Access Compliance Report

Public Rights-of-Way

(Curb Ramps)

Intersection ID: 49930	Main Street: PAXTON_RUN_RD	Cross Street: CHAMBERLIN_RD	Location: SE
ADA ID: 5262E4F9AD7B	Ramp Type: Perp	Initial Pass/Fail: Fail	Overall Compliance: No
		Severity Score: 22.5

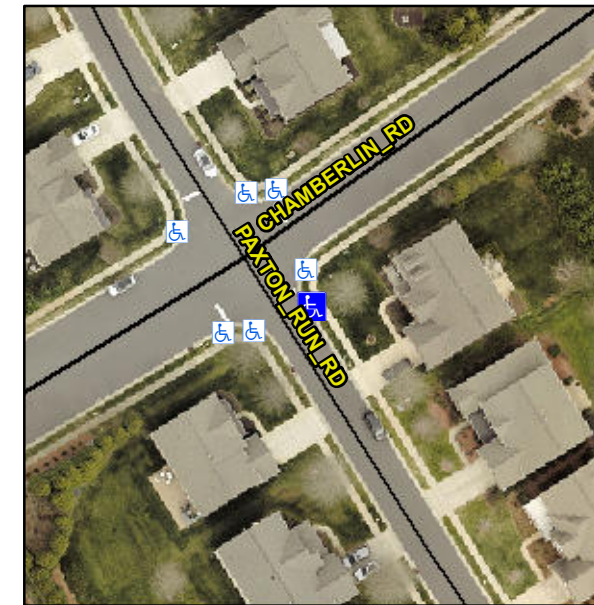
Not Found, R304.5.1, R304.2.2, R304.5.3

Compliance	Description	Data	Compliance	Description	Data
N/A	Ramp Length (in)	47.0	No	Ramp Slope (%)	11.5
No	Ramp Width (in)	47.0	No	Ramp XSlope (%)	4.3
N/A	Flare Type LT	N/A	N/A	Flare Type RT	N/A
N/A	Flare Slope LT (%)	N/A	N/A	Flare Slope RT (%)	N/A
N/A	Flare Traversable LT?	N/A	N/A	Flare Traversable RT?	N/A
N/A	Landing Length (in)	N/A	N/A	DWS Provided?	N/A
N/A	Landing Width (in)	N/A	N/A	DWS Contrast?	N/A
N/A	Landing Slope (%)	N/A	N/A	DWS Length (in)	N/A
N/A	Landing X Slope (%)	N/A	N/A	DWS Full Width?	N/A
N/A	Landing Curb? (Y/N)	N/A	N/A	DWS Offset (in)	N/A
N/A	Shared Landing?	N/A			
N/A	Gutter Ponding?	N/A	N/A	Gutter Slope (%)	N/A
N/A	Gutter Lip Ht (in)	N/A	N/A	Gutter X Slope (%)	N/A
N/A	Painted X Walk1?	No	N/A	Painted X Walk2?	N/A
	X Walk 1 Direction	To SW		X Walk 2 Direction	N/A
N/A	X Walk 1 Width (in)	N/A	N/A	X Walk 2 Width (in)	N/A
	X Walk 1 Slope (%)	1.8		X Walk 2 Slope (%)	N/A
	X Walk 1 X Slope (%)	4.2		X Walk 2 X Slope (%)	N/A

Remove & Replace Entire Ramp.
